Alert Service Bulletin No. 232

E-MAG Spark Plug Adapter Inspection

Figure 2 - Spark Plug Adapter Identification
(E-MAG) EMC00101 & EMC00201 - AFFECTED

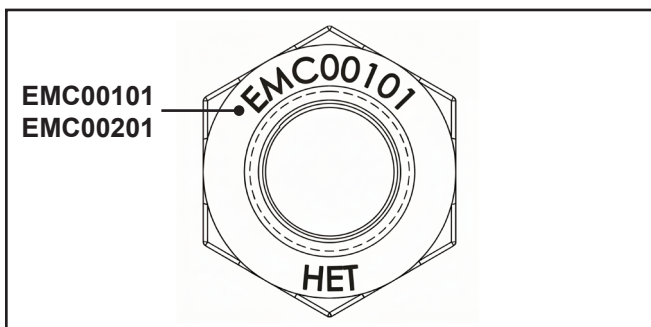
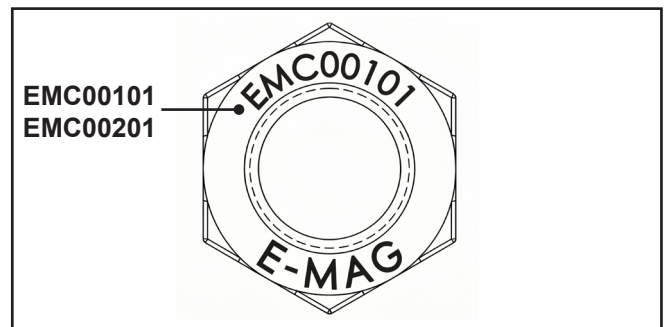
- (1) HET has discovered that a number affected spark plug adapters were found to be undersized at the external thread major diameter.
 - (a) This condition may cause the spark plug adapter to lose torque and/or dislodge from the cylinder during engine operation.

- (1) Gain access to the spark plug adapters IAW applicable aircraft engine maintenance manual and service instructions.
- (2) Inspect each spark plug adapter IAW Figures 1 thru 4.
 - (a) Spark plug adapters stamped "HET" are **not affected** by this ASB. Continue to § 3.E. Maintenance Record.
 - (b) Spark plug adapters stamped "E-MAG" are **affected** by this ASB.
 - 1) If any adapter P/N is affected, continue to § 3.C., Corrective Action.
 - 2) If none of the adapter P/Ns are affected, continue to § 3.E., Maintenance Record.

**Figure 5 - Spark Plug Adapter Thread
Major Diameter**

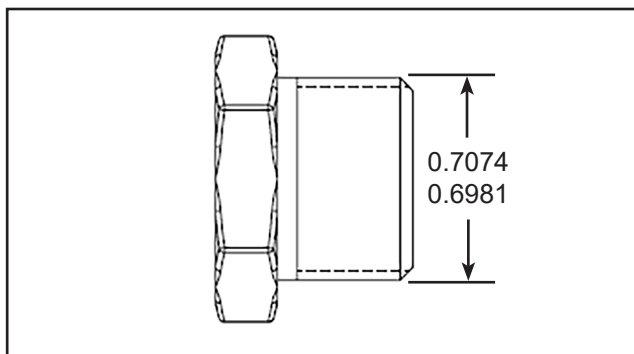
- 4) Using calipers, measure the external thread major diameter of the spark plug adapter (See Figure 5):
 - a) Measurement must be within 0.6981 - 0.7074 (17.73 – 17.97mm).

- b) If the spark plug adapter measurement is within tolerance, continue to step 5.
 - c) If the measurement is found out of tolerance, replace the spark plug adapter with a new adapter that is not affected by this ASB. Continue to step 6.
